AMENDMENTS TO THE DRAWINGS:

REMARKS

Though Applicants disagree with the Examiner's objection to the title, Applicants have amended the title to read: "Decoding Apparatus, Decoding Method, and Program to Decode Low Density Parity Check Codes." Applicants have also amended the specification to correct a typographical error.

FIG. 1 - Prior Art

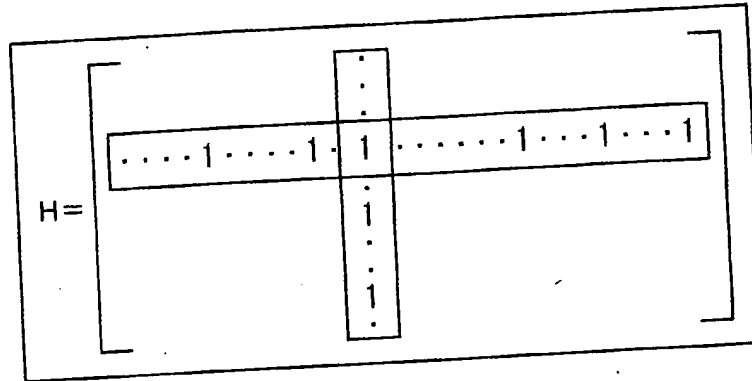
Applicants respectfully request reconsideration and withdrawal of the objection to the drawings. The drawings comply with 37 C.F.R. § 1.83(a) because Applicants have amended Figures 1-11, 12A, 12B, 12C, 13, and 14 as suggested by the Examiner on page 2 of the outstanding Office Action. Specifically, Applicants have amended Figures 1-11, 12A, 12B, 12C, 13, and 14 to include the label "Prior Art."
